ERCOT Response to Comments on AGS-ESR Test Requirements

February 2025 IBRWG

ERCOT has posted the FAQ document on the February 2025 IBRWG website

Performance Criteria

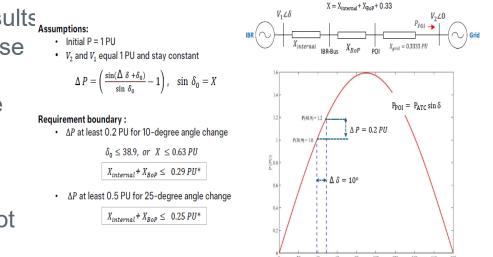
Q11. For the phase angle jump test, is an increase of 0.2 pu required for a 10-degree angle drop?

Yes, it is required. However, if the current limit in the inverter is reached when the angle jump is applied, the performance criteria may not apply.

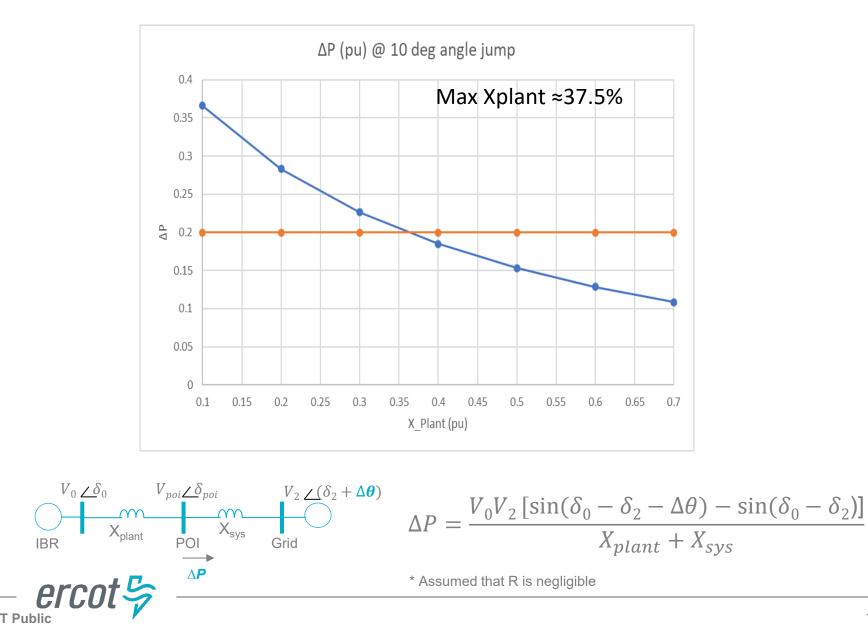
Q12. Tesla's analysis and simulations results reveal site-specific dependencies for phase V_2 and angle test outcomes ΔP

- Recommends adding flexibility to the requirement based on site-specific impedance
- Power change is a function of total impedance and the requirement is not always achievable

Theoretically, voltages at terminal and voltage source must be higher than Tesla's analysis assumption (e.g., assumed constant at 1.0 pu)

- The success criteria is based on the worst-case total impedance approximately 70% (i.e. maximum <u>plant impedance</u> approximately 37% @ X/R ratio = 10). In addition, the criteria is based on testing various OEM models
- Refers to the knee curves in the next slide

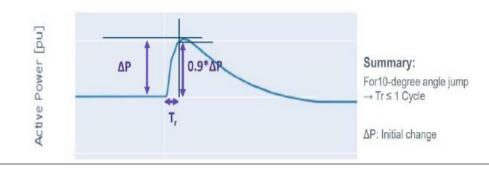
Q13. Does the one-cycle condition for rise time apply to the case with a 25degree jump, or is it only relevant to the 10-degree case?

- The response time to 90% of the initial change in instantaneous active power should occur within one cycle. The criteria is applicable to both 10-degree and 25-degree angle jump tests
- The time to reach the power peak (1 cycle) is not a function of input (i.e. angle step size), it is based on the plant inductance between two sources. Therefore, it should satisfy the 1 cycle requirement.
- If the current limit in the inverter is reached when the angle jump is applied, the performance criteria may not apply.
- The criteria is also based on tests of various OEM models and a review of practices in other regions
